AUI-C2C transmitter equalization control interface proposal

(Addressing comments 11059, 11082)

Adee Ran, Intel

Figure 120F-2—Typical 100GAUI-1, 200GAUI-2, and 400GAUI-4 C2C application

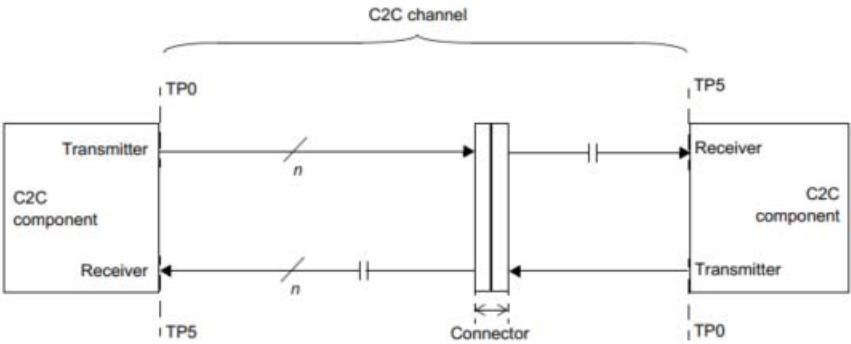
The 100GAUI-1, 200GAUI-2, and 400GAUI-4 C2C transmitter on each end of the link is adjusted to an appropriate setting based on channel knowledge. If implemented, the transmitter equalization feedback mechanism described in 120D.3.2.3 may be used to identify an appropriate setting. The adaptive or adjustable receiver performs the remainder of the equalization.

Annex 120F text refers to a control interface of 120D - 3-tap TxEq using absolute tap values

Figure 120F-4—Transmitter equalizer functional model

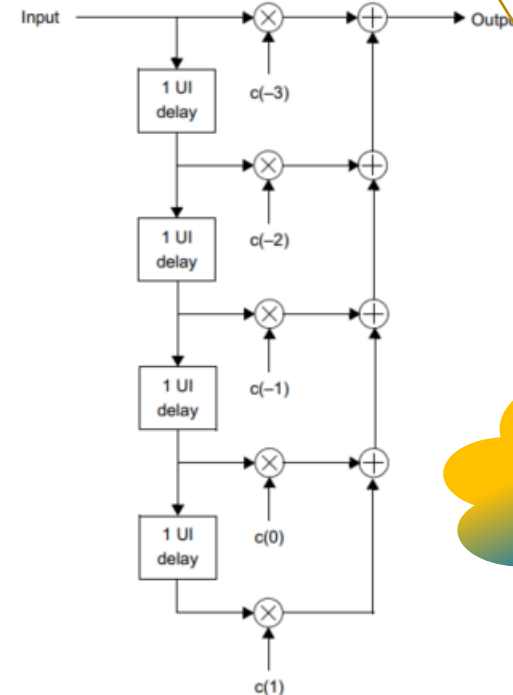
The TxEq is specified with 5 taps

Mess...
A new control interface is required

Each transmitter includes programmable equalization to compensate for the frequency-dependent loss of the channel and to facilitate data recovery at the receiver. The functional model for the transmit equalizer is the five-tap transversal filter shown in Figure 120F-4. Transmitter output waveform specifications are provided in Table 120F-1. The state of the transmit equalizer may be configured via the transmitter control interface described in 120F.3.1.4.

Figure 120F-2—Typical 100GAUI-1, 200GAUI-2, and 400GAUI-4 C2C application

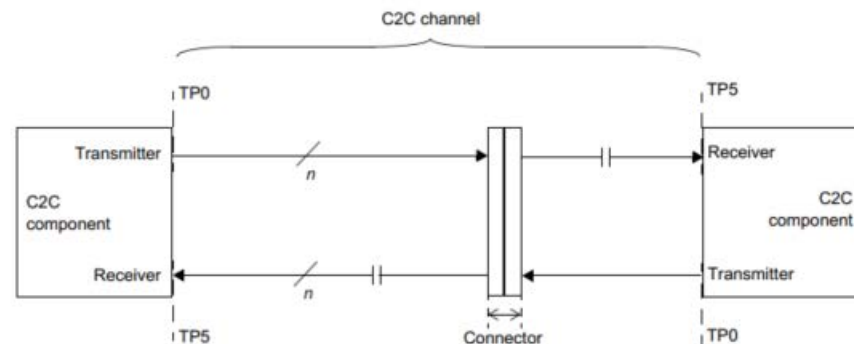
The 100GAUI-1, 200GAUI-2, and 400GAUI-4 C2C transmitter on each end of the link is adjusted to an appropriate setting based on channel knowledge. If implemented, the transmitter equalization feedback mechanism described in 120D.3.2.3 may be used to identify an appropriate setting. The adaptive or adjustable receiver performs the remainder of the equalization.

The 100GAUI-1, 200GAUI-2, and 400GAUI-4 C2C transmitter on each end of the link is adjusted to an appropriate equalization setting, which may be based on channel knowledge. If implemented, The transmitter equalization feedback mechanism described in 120F.3.3 may be used to identify an appropriate setting of the link partner. The adaptive receiver performs the remainder of the equalization.
